Docket No. LC 78

IDAHO POWER COMPANY,

2021 Integrated Resource Plan

FINAL COMMENTS

Figure 1

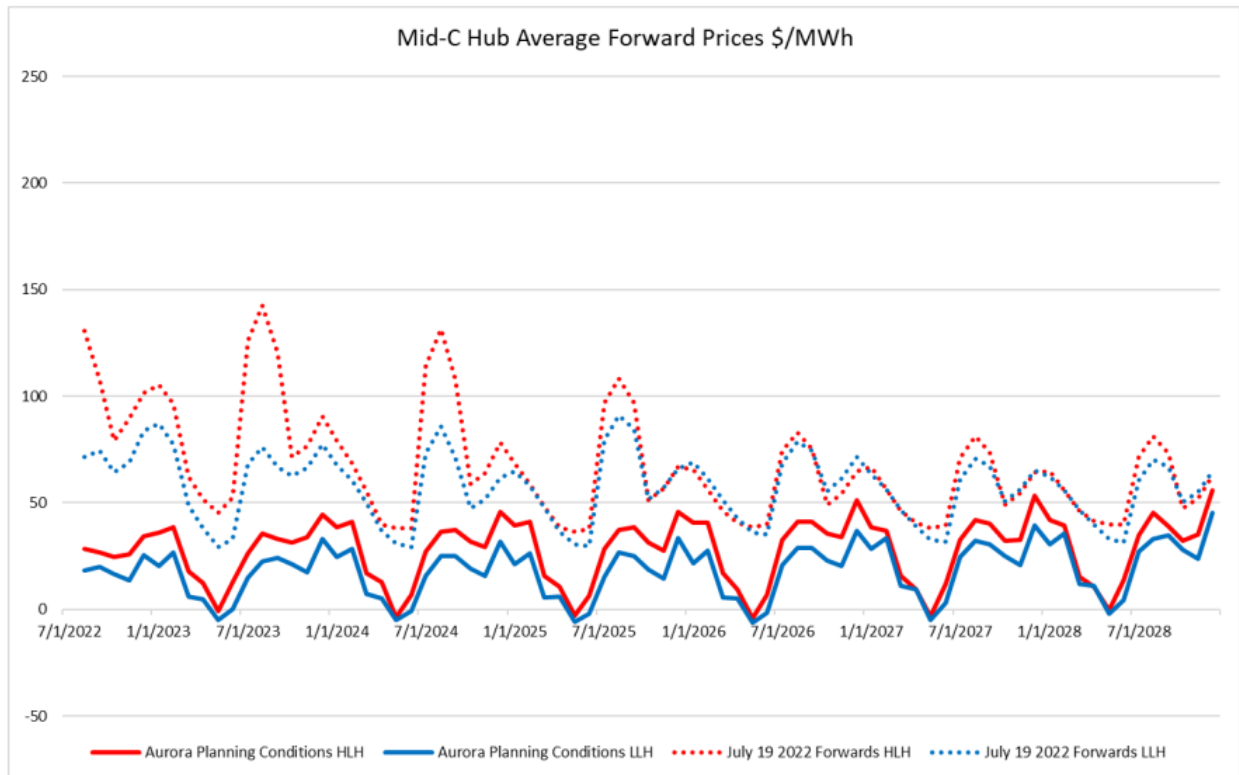
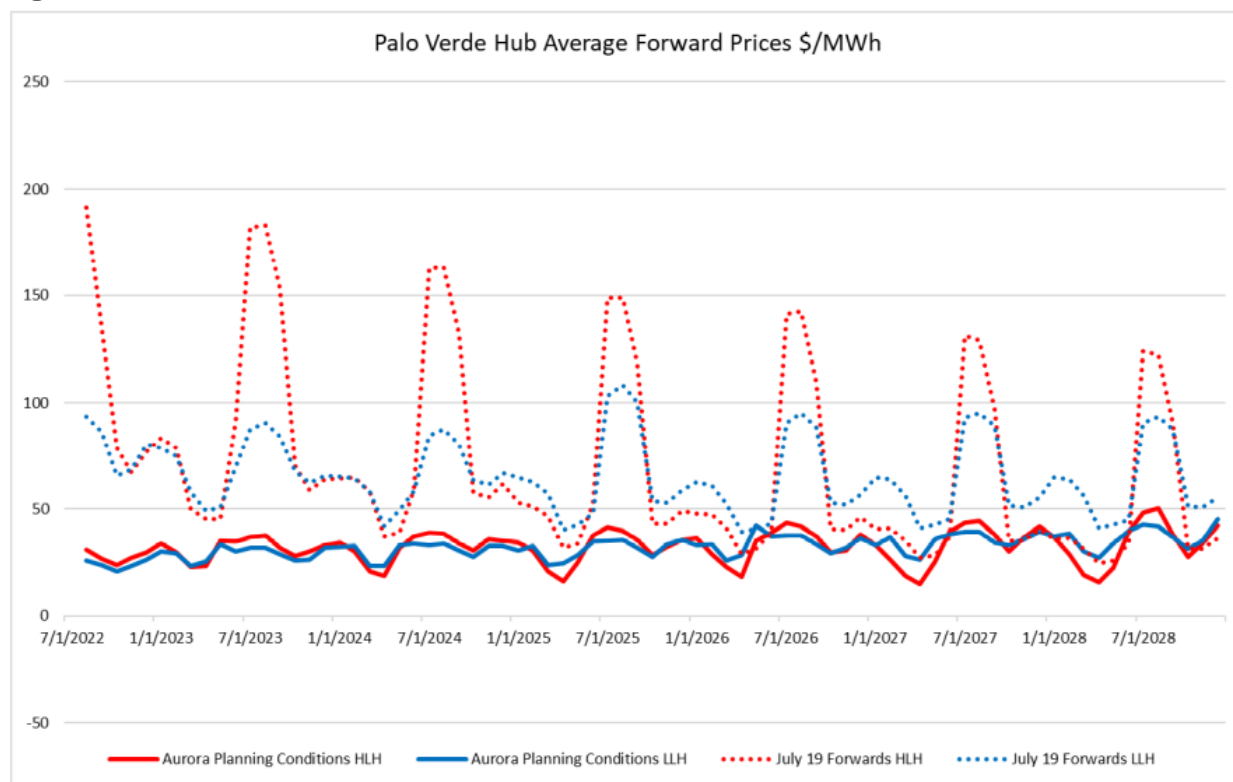
Staff believes Idaho Power's 2021 IRP significantly underestimates wholesale energy prices during the years of the Action Plan and beyond. This underestimation biases portfolio modeling in favor of energy storage, market purchases, and by extension, the construction of transmission resources for expanding capacity for market purchases. Staff observed a wide disparity between forecasted prices for Mid-Columbia (Mid-C) and actual 2021 prices. The Company pointed to the low hydro conditions last year, offering a plausible explanation for a one-off event. However, a comparison of the forward trading curve for two wholesale markets

Idaho Power plans to import from (Mid-C and Palo Verde) with the Company's forecast of these prices in the 2021 IRP, that Idaho Power presents in Reply Comments, shows a persistent underestimation of wholesale prices in both these markets for nine years.

Staff does not find Idaho Power’s arguments in defense of the 2021 IRP’s wholesale price forecasts persuasive. In Reply Comments, Idaho Power makes three points. First, the Company states that “the ex-ante wholesale prices generated by AURORA are based on typical or planning conditions generated before actual conditions occur.”¹⁶ IPC goes on to say: “It should not be a surprise, then, that actual wholesale prices differ from AURORA’s ex-ante modeled prices.” Staff agrees that it would be unreasonable to expect a model to forecast the exact prices that eventually occur, but the difference between a good model of prices and actual prices is the jagged spikes of day-to-day trades in a real market in contrast to the relatively smooth estimate a model generates. However, a good model would deviate from reality without bias, with real prices falling both higher and lower than the model predicts, producing equal error in both directions. Instead, Idaho Power’s modeling of wholesale prices shows a clear downward bias. Real prices are consistently and significantly higher.
